**ADDENDUM NO. 1
NOVEMBER 15, 2024**

**PROJECT: MILLSAP WSC
CID 04 – VALVE REPLACEMENTS**

ADDENDUM 1

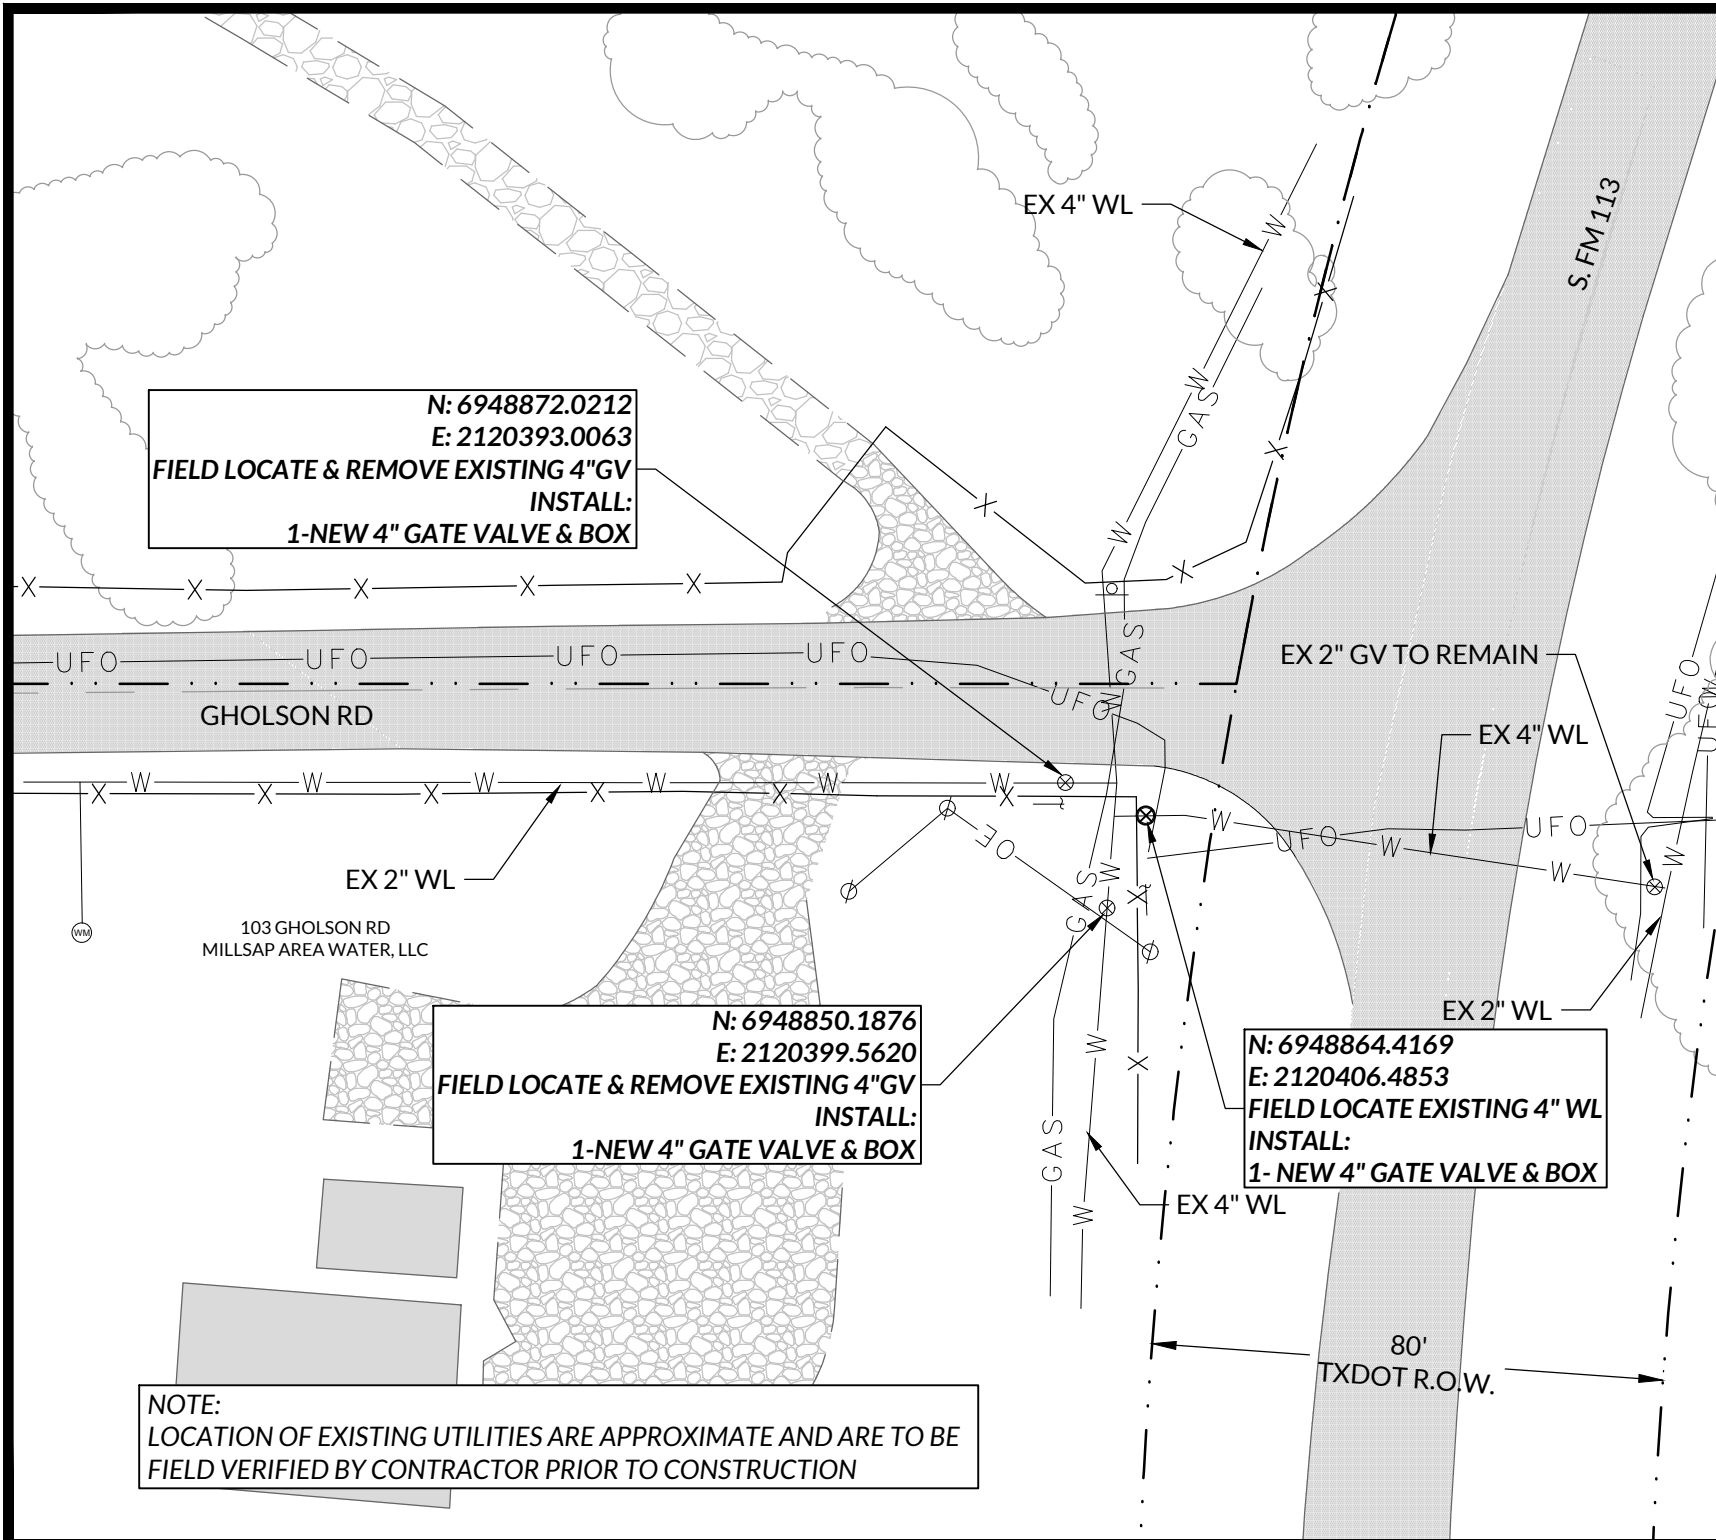
- 1) The proposed valve replacements shall be per the attached exhibit to replace the plan view on SHEET
03 of the plans.

N: 6948872.0212
 E: 2120393.0063
FIELD LOCATE & REMOVE EXISTING 4"GV
INSTALL:
1-NEW 4" GATE VALVE & BOX

N: 6948850.1876
 E: 2120399.5620
FIELD LOCATE & REMOVE EXISTING 4"GV
INSTALL:
1-NEW 4" GATE VALVE & BOX

N: 6948864.4169
 E: 2120406.4853
FIELD LOCATE EXISTING 4" WL
INSTALL:
1- NEW 4" GATE VALVE & BOX
